CMD: 21-H11

CNSC staff assessment of the requests for restart submitted by Bruce Power and OPG pursuant to Orders issued due to hydrogen equivalent concentration discovery events at Bruce NGS A and B

One-Day Public Hearing

Figure 1 - Pressure tube at end fitting (the yellow shaded region represents the region of elevated Heq)

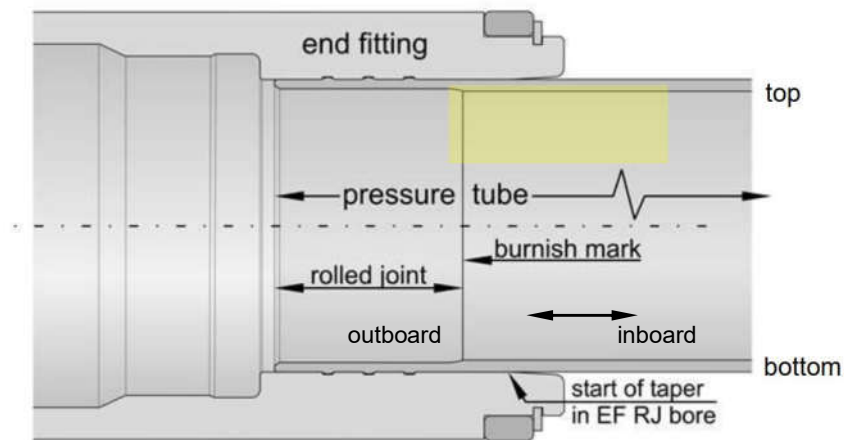
CNSC staff informed the DO that estimation of the fracture toughness of the pressure tubes are called into question for the region of pressure tubes in extended operation near the outlet burnish mark for the following reasons:

1. Uncertainty associated with the model predictability for Heq uptake,
2. The high Heq measurements discovered at Bruce NGS A and B Units 3 and 6 exceed the validity range of the current fracture toughness model,
3. The absence of scrape sample measurements in the same areas in the pressure tubes of the operating units that are being operated beyond 210,000 equivalent full power hours (EFPH).

5. The region of interest should be defined as the first 75 mm inboard of the outlet burnish mark and the full circumference of the pressure tube.
6. The criteria are independent of outage type (planned or unplanned) since the risk of pressure tube failure would be similar in both scenarios.

In the absence of the root cause for the elevated Heq and until the phenomenon is modelled, CNSC staff have conservatively extended the region of interest to 75 mm axially from the outlet burnish mark, encompassing the full circumference, to evaluate pressure tube fitness for service. This expanded region of interest will encompass the location of the first inboard scrapes taken using the current industry standard practice (nominally 60 to 70 mm from the BM) and will provide a margin for future expansion of the region of elevated Heq should that occur with continued operation.

5. The region of interest applicable to the evaluations described above should be expanded to 75 mm inboard of the outlet burnish mark and the full circumference of the pressure tubes until evidence is available to confirm that the region of interest is smaller, and will remain so, as Bruce Power has proposed.
